CONSTRUCTION OPERATIONS AND SITE UTILIZATION PLAN

CSK-04 ADDENDUM # 1		PBC Onahan 6634 W. Raven Street		2241 S. Wabash Avenue Chicago, Illinois 60616 Phone 312.567.1000 / Fax 312.567.9690	
Project #: 11-0720	Drawn By: AV	Date: 2011/12/29	BauerLatoza STUDIO <small>Architecture Historic Preservation Landscape Architecture Urban Design</small>		
Dwg File: C-1.1	Checked By: HG	© Bauer Latoza Studio, 2011

CPS William J. Onahan Elementary
6634 W. Raven Street
Chicago, IL 60631

ISSUE: ADDENDUM 1
 TITLE: COLUMN SCHEDULE
 REFERENCE: S1.0

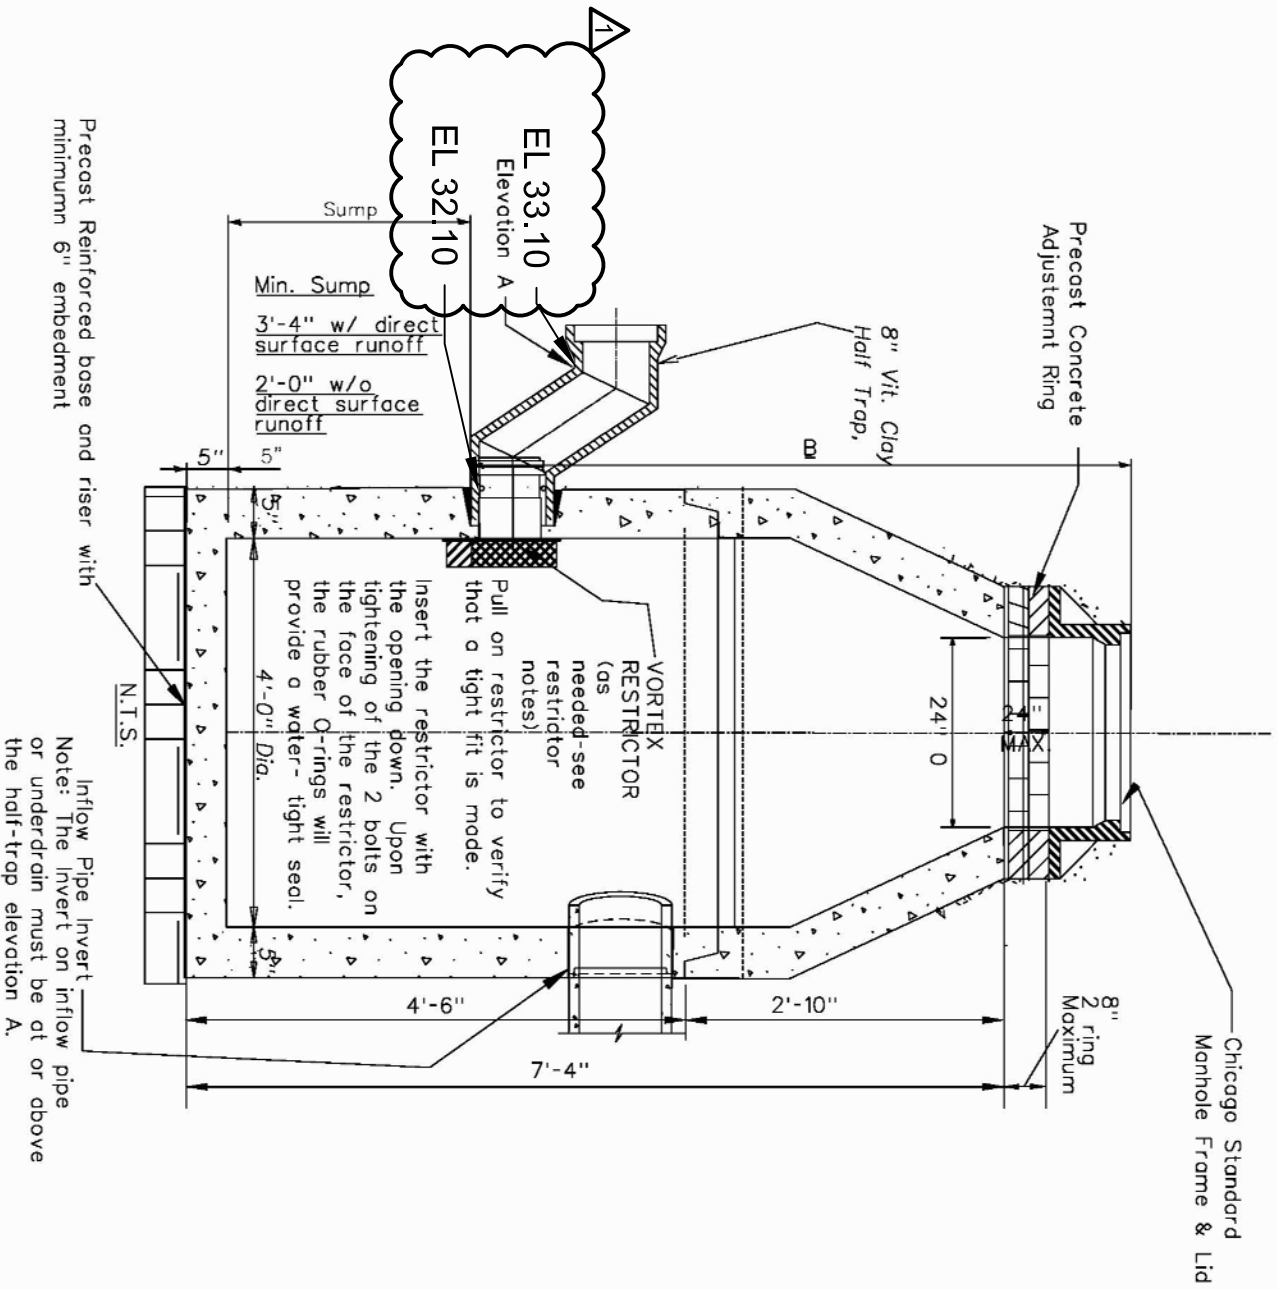
DEMOLISH/REMOVE & DISPOSE OFF FOUNDATIONS AND ALL ASSOCIATED UTILITY CONNECTIONS TO MODULAR, CUT AND CAP ALL INFRASTRUCTURES BELOW GRADE IN ACCORDANCE WITH THE CONTRACT DOCUMENTS. PROVIDE A TEMPORARY SURFACE OF 4" DEPTH OF CRUSHED LIMESTONE, TO BE USED FROM JANUARY 2013 THROUGH APRIL 2013

DEMOLISH/REMOVE EXISTING MODULAR BUILDING (BY OTHERS)

PARTIAL EXISTING BASEMENT/FOUNDATION PLAN
 3/16"=1'-0"

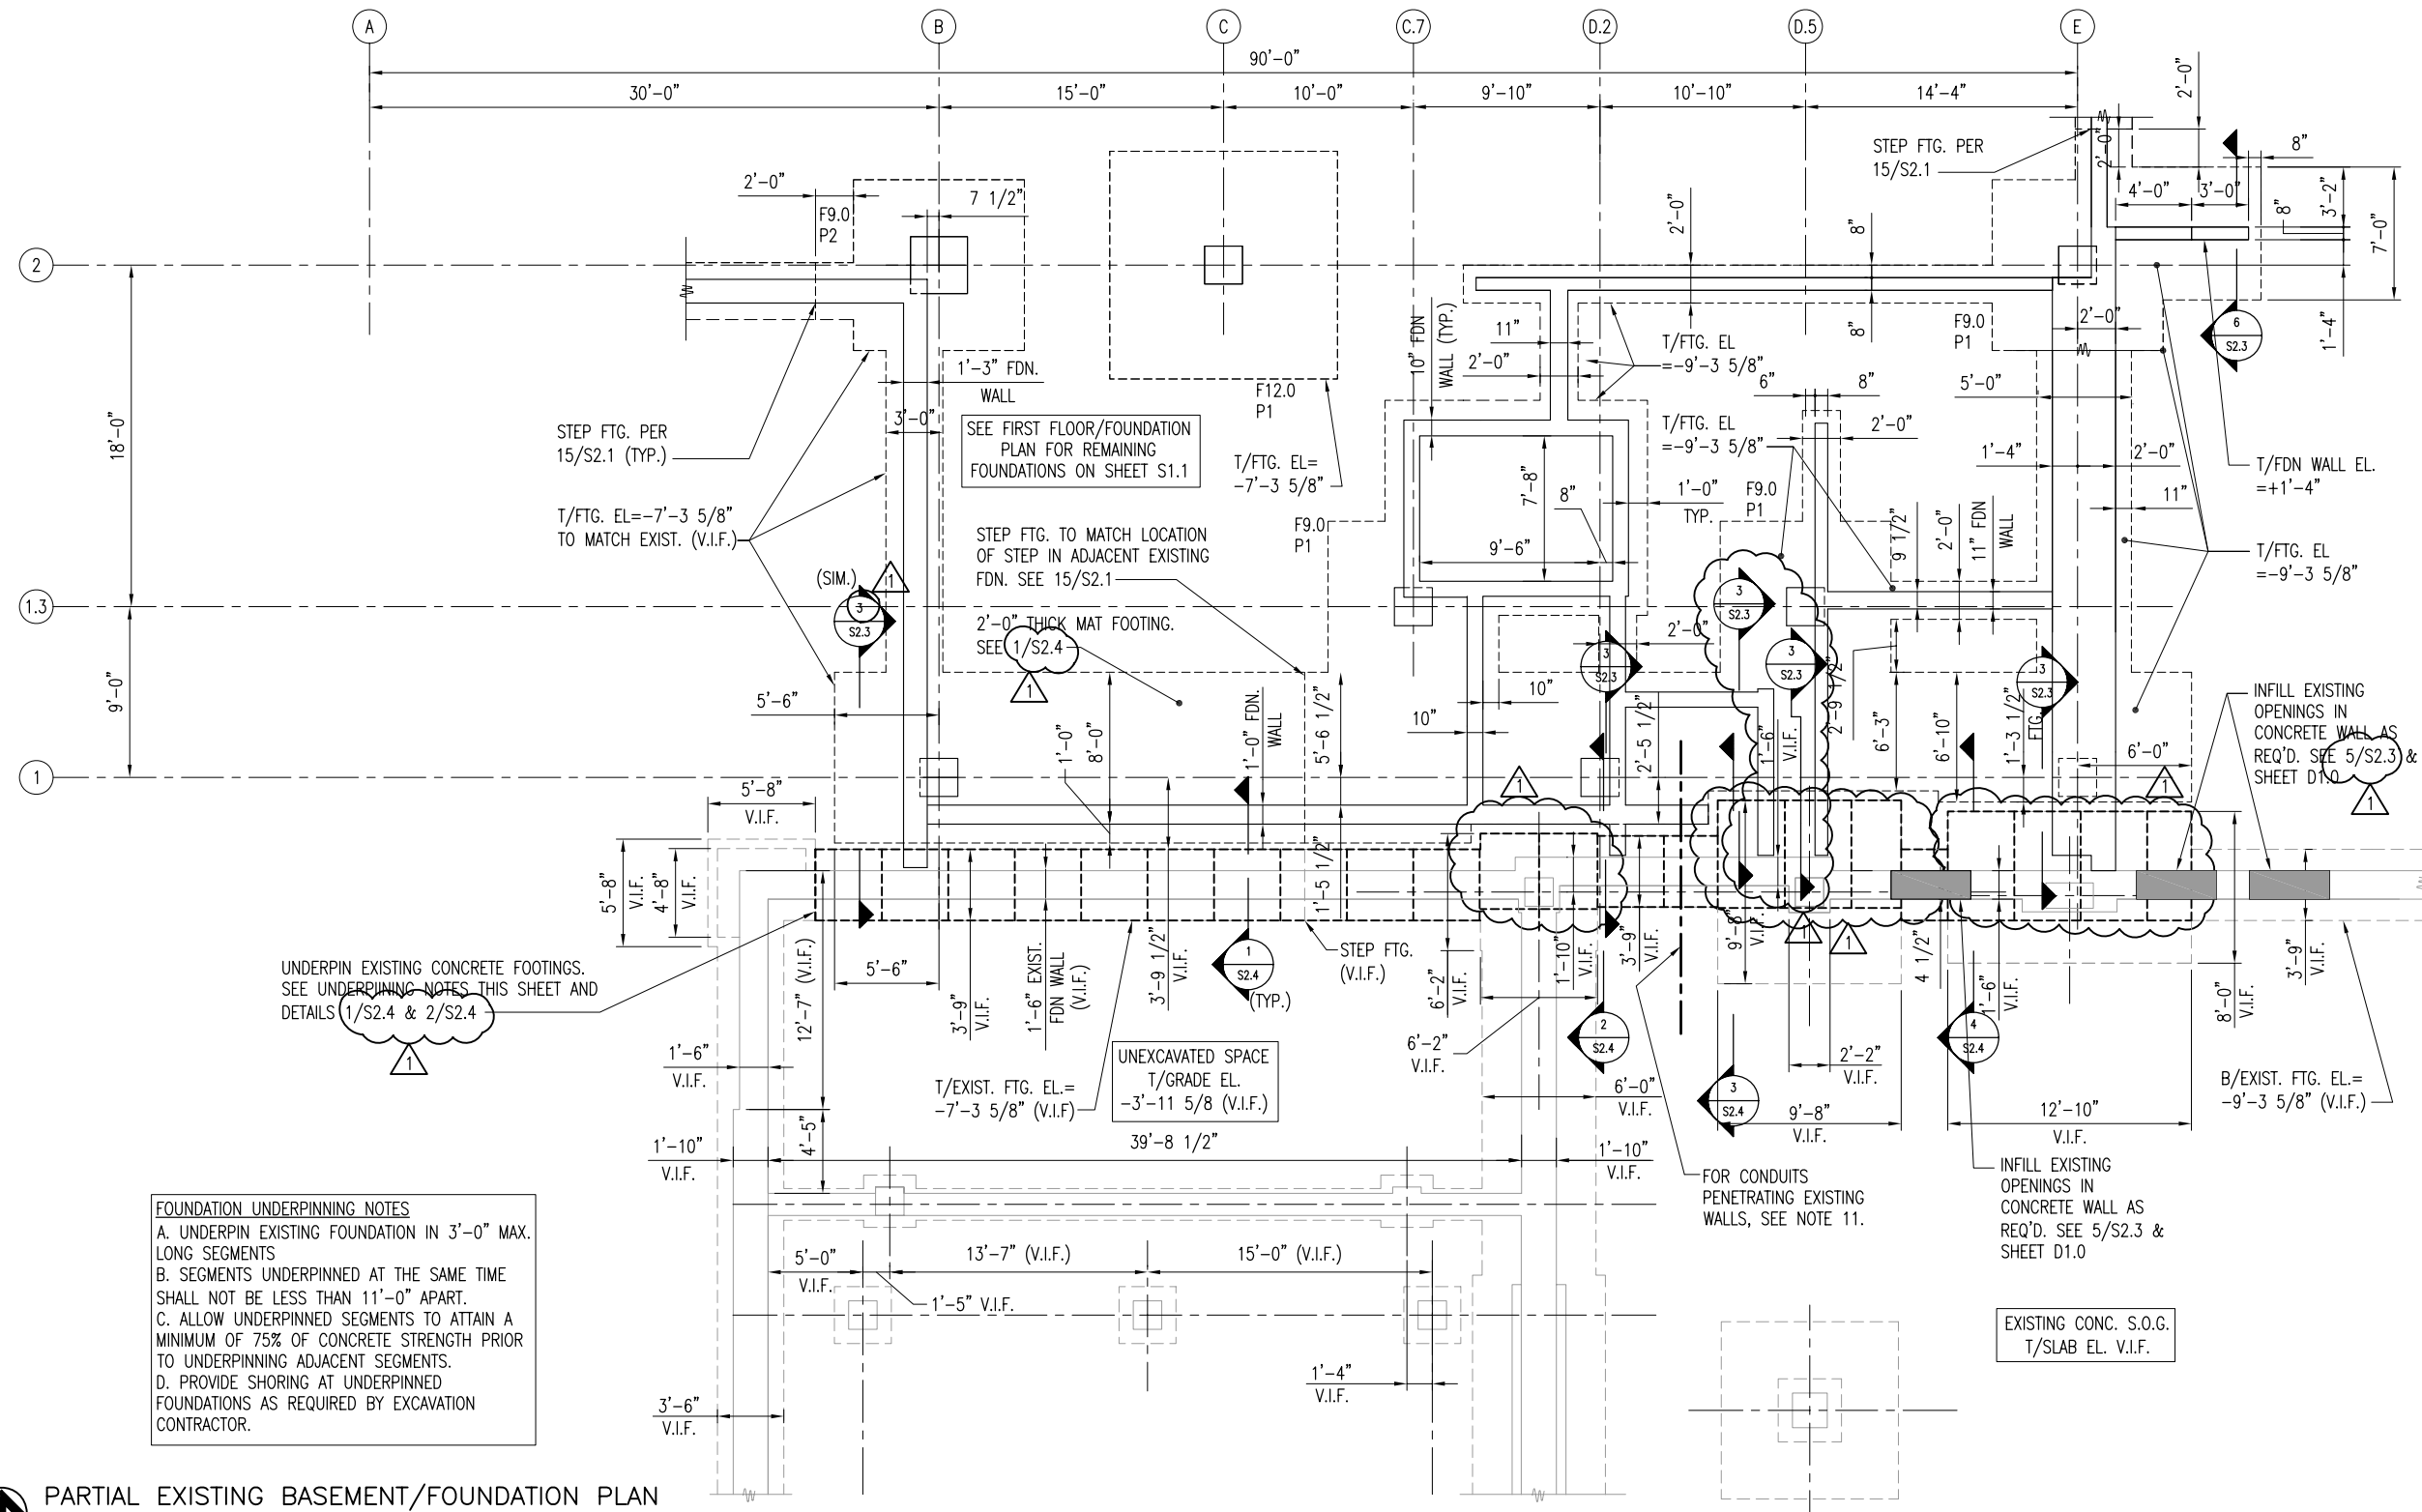
FOUNDATION UNDERPINNING NOTES
 A. UNDERPIN EXISTING FOUNDATION IN 3'-0" MAX. LONG SEGMENTS
 B. SEGMENTS UNDERPINNED AT THE SAME TIME SHALL NOT BE LESS THAN 11'-0" APART.
 C. ALLOW UNDERPINNED SEGMENTS TO ATTAIN A MINIMUM OF 75% OF CONCRETE STRENGTH PRIOR TO UNDERPINNING ADJACENT SEGMENTS.
 D. PROVIDE SHORING AT UNDERPINNED FOUNDATIONS AS REQUIRED BY EXCAVATION CONTRACTOR.

TYPICAL WALL SLEEVE DETAIL

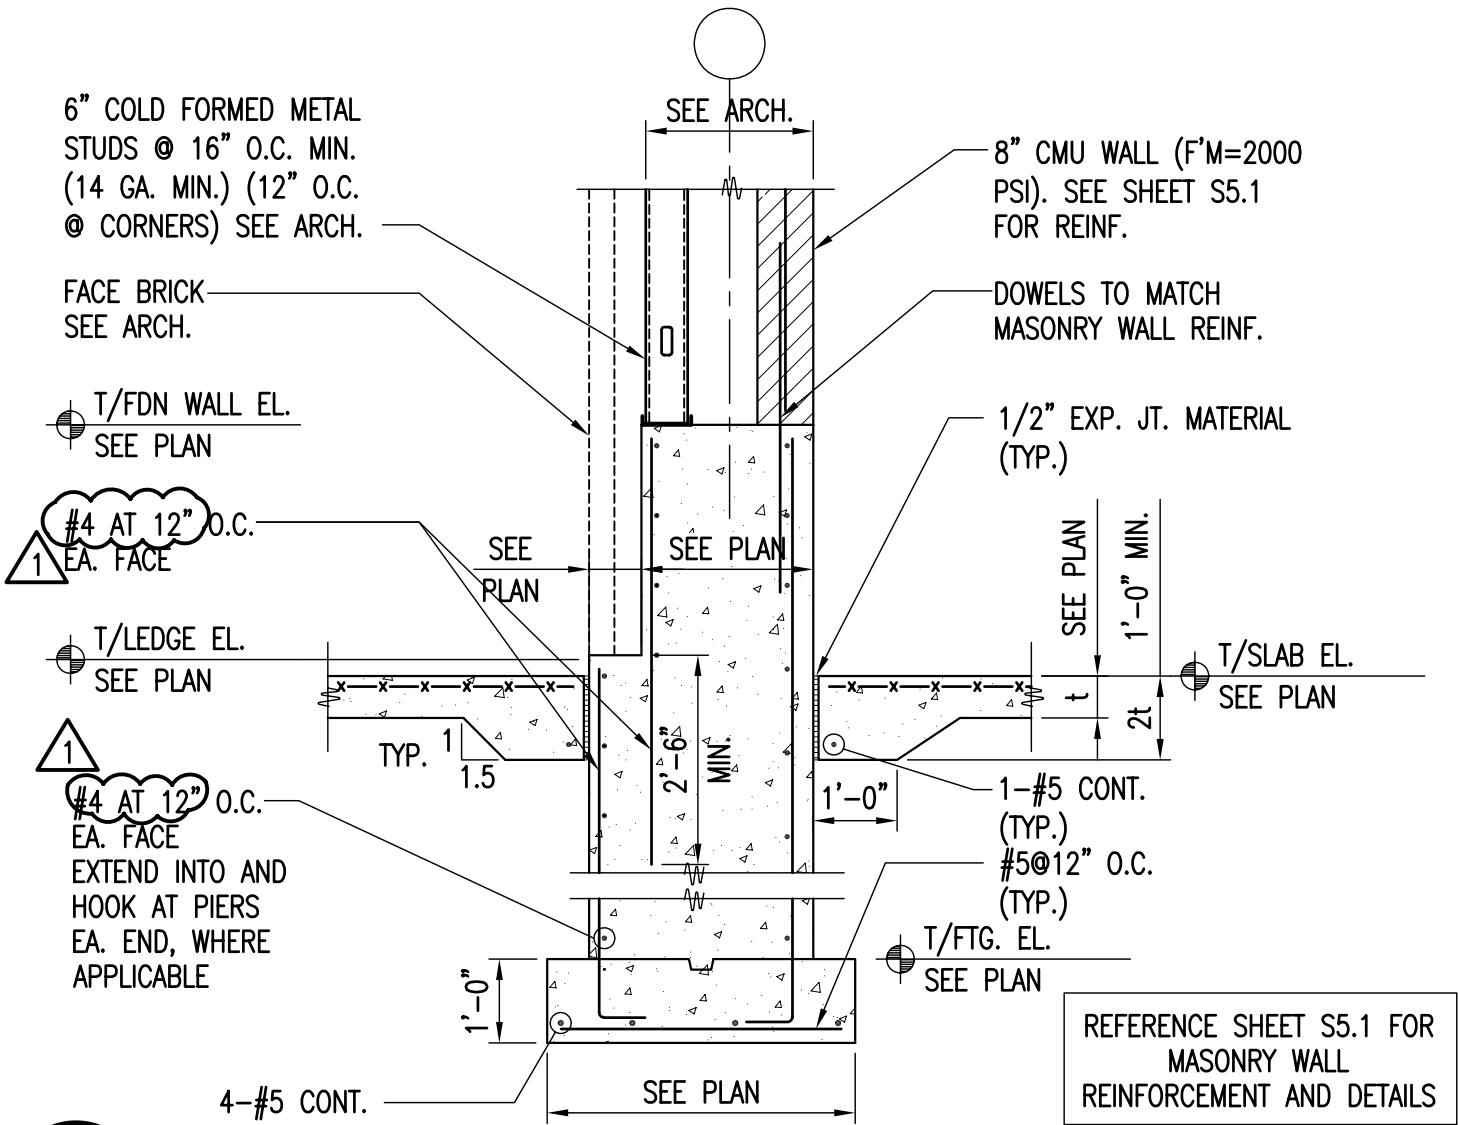
SPACE SLEEVES FOR CONDUIT A MINIMUM OF 3 CONDUIT DIAMETERS ON CENTER OR 4 INCHES. WHICHEVER IS GREATER DO NOT INTERRUPT FDN. WALL REINF. IF THIS CRITERIA IS NOT MET, TREAT THE ROW OF SLEEVE OPENINGS AS ONE CONTINUOUS CONCRETE WALL OPENING AND PROVIDE ADDITIONAL REINFORCEMENT PER DETAIL 10/S2.1.

1 TYPICAL SECTION @ CANT. ROOF BEAM AT COLUMN FLANGE
 S3.4 3/4"=1'-0"

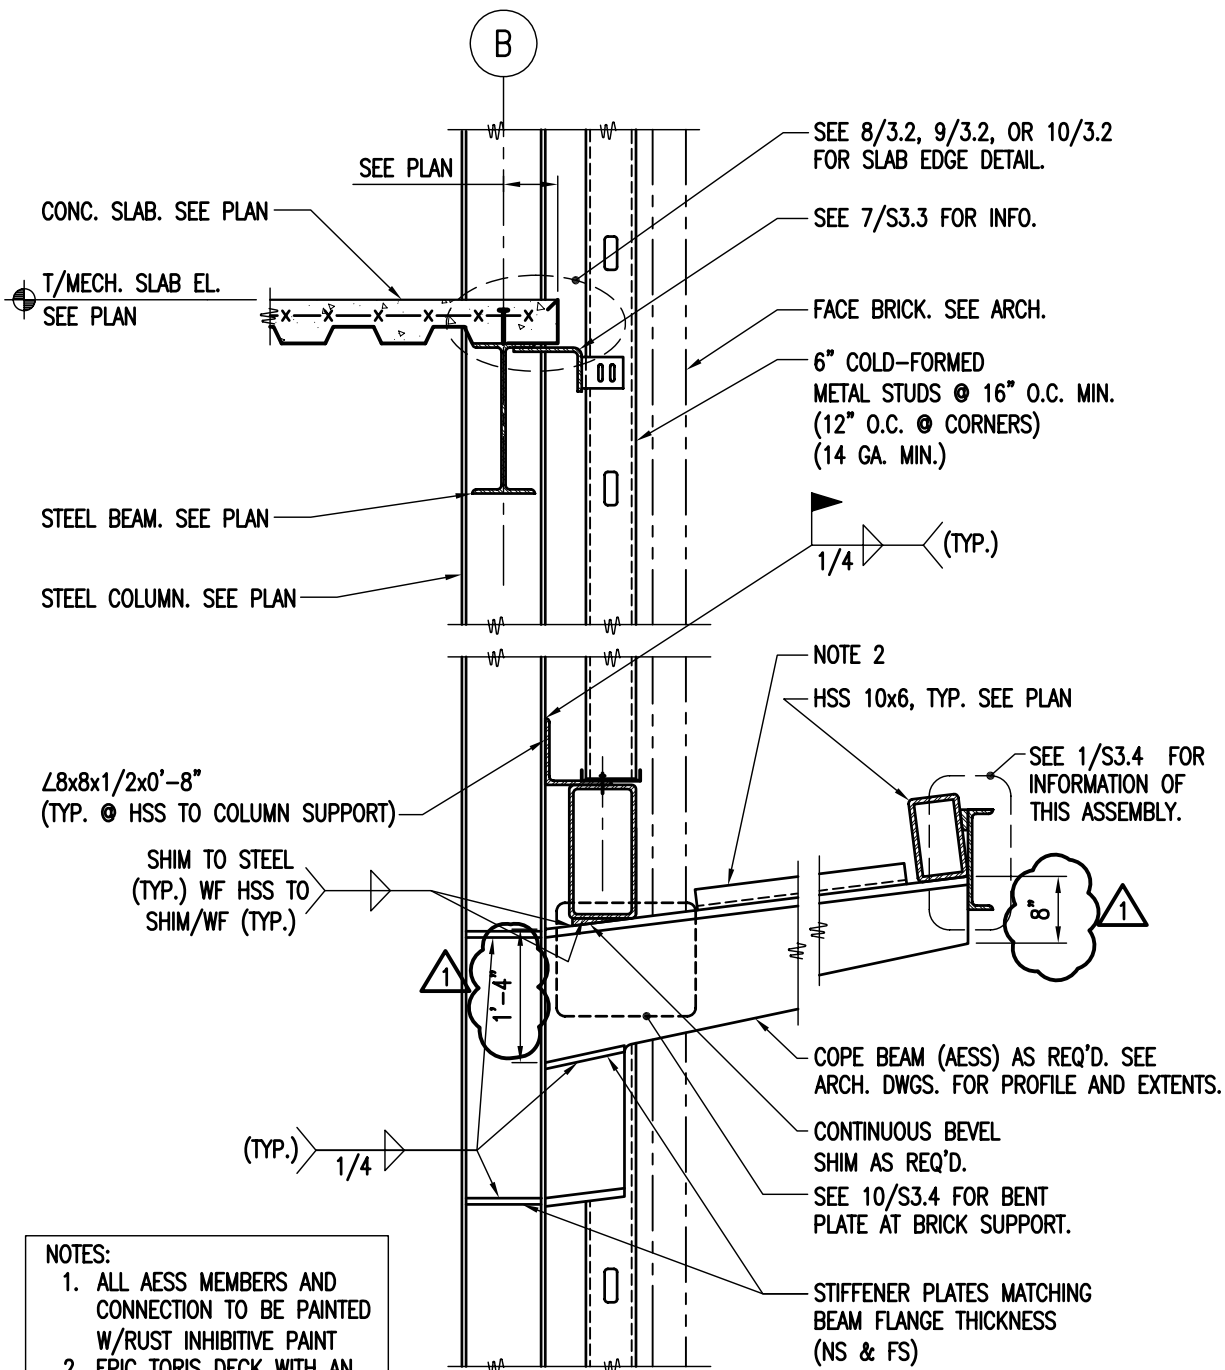
NOTE:
 1. CHANNELS TO BE MITERED @ ALL ROOF EDGE CORNERS & SHALL BE GROUND FLUSH.
 2. ALL AESS MEMBERS AND CONN. TO BE PAINTED W/RUST INHIBITIVE PAINT

9
TYPICAL SECTION @ CANOPY BEAM AT COLUMN CONNECTION
 S3.4 3/4"=1'-0"

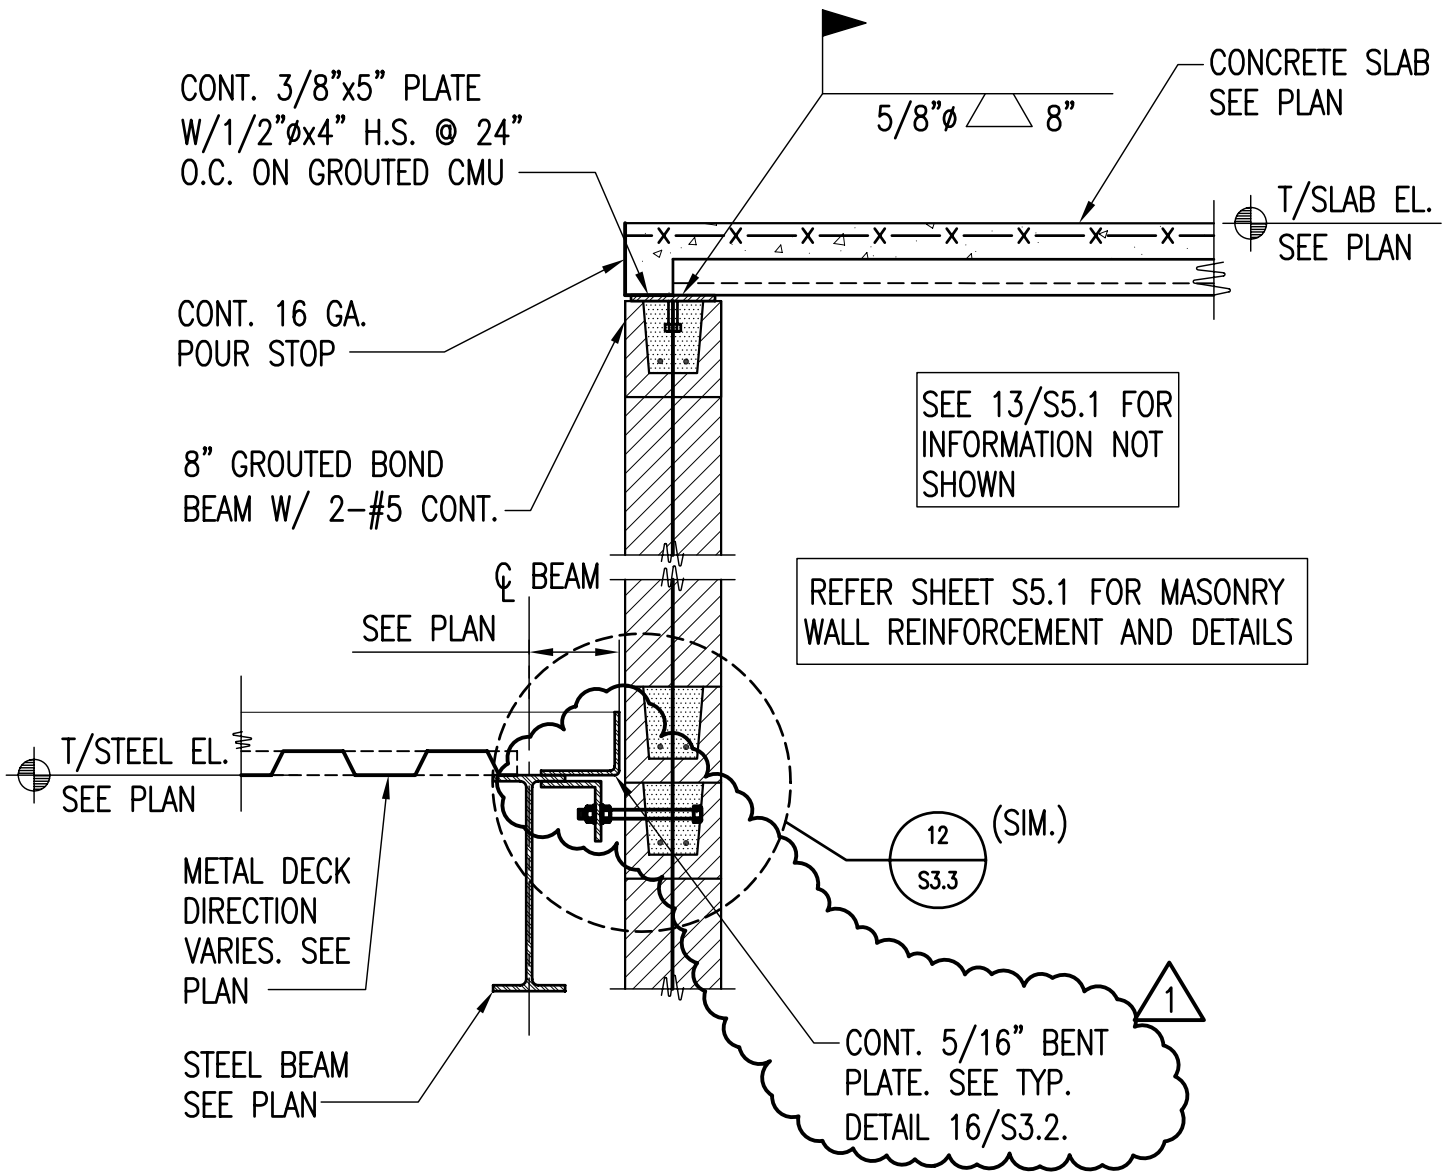
- NOTES:**
1. ALL AESS MEMBERS AND CONNECTION TO BE PAINTED W/RUST INHIBITIVE PAINT
 2. EPIC TORIS DECK WITH AN ADDITIONAL FLAT PROFILE METAL SHEET (MIN. 20 GA.) AT UNDERSIDE AT OVERHANG. SEE PLAN FOR INFORMATION.
